# UNITED STATES PATENT AND TRADEMARK OFFICE

APPLICATION NO.	FILING DATE	FIRST NAMED INVENTOR	ATTORNEY DOCKET NO.	CONFIRMATION NO.
10/085,493	02/27/2002	Jacquelin A. Vantroostenberghe	Male Urinary System	4926
7590 12/17/2003			EXAMINER	
DAVID G. HENRY 900 Washington Avenue P.O. Box 1470 Waco, TX 76701			BOGART, MICHAEL G	
			ART UNIT	PAPER NUMBER
			3761	/D

# Office Action Summary

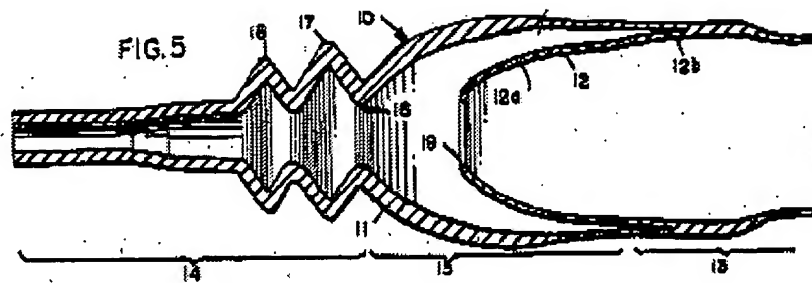
Claim 1 is rejected under 35 U.S.C. § 103(a) as being unpatentable over  
Schneider (US 4,626,250).

Schneider teaches a male urinary system comprising:

penis/urinary collection interface unit (10), said penis/urinary collection interface unit (10) a primary receiver unit (12) for accommodating at least a portion of the length of a male penis during urination, and a secondary containment unit (15) in which said primary receiver unit (12) is at least partially nested with proximal margins (12b) of said secondary containment unit (15) and primary receiver (12) unit being fused to prevent fluid ingress or egress past the line of juxtaposition (12b), said primary receiver unit (12) being positioned relative to said secondary containment unit (15) whereby a gap (20) is formed between the outer surface of said primary receiver unit (12) and the inner surface of said secondary receiver unit (15), said gap (20) extending at least from the distal end (12a) of said primary receiver unit (12) and the said line of juxtaposition (12b) between said secondary containment unit (15) and said primary receiver unit (12), said primary receiver unit (12) opening (19) at its distal end (12b) into said secondary containment unit (15) near the distal end (16) of said secondary containment unit (15);

conduit means (14) attached to said distal end (16) of said secondary containment unit (15) for collecting urine flowing from said distal end (12b) of said primary receiving unit (12)(see Fig. 5, below).

Schneider therefore expressly teaches every element of the claimed invention except for a urine receptacle.

The device taught by Schneider is clearly designed to be emptied into something. Similar devices in the art provide receptacles to collect urine, as discussed by the reference (col. 1, line 61). At the time of the invention, it would have been obvious to one of ordinary skill in the art to provide a suitable receptacle with the device as taught by Schneider in order to provide a means of collecting urine expelled from the device.
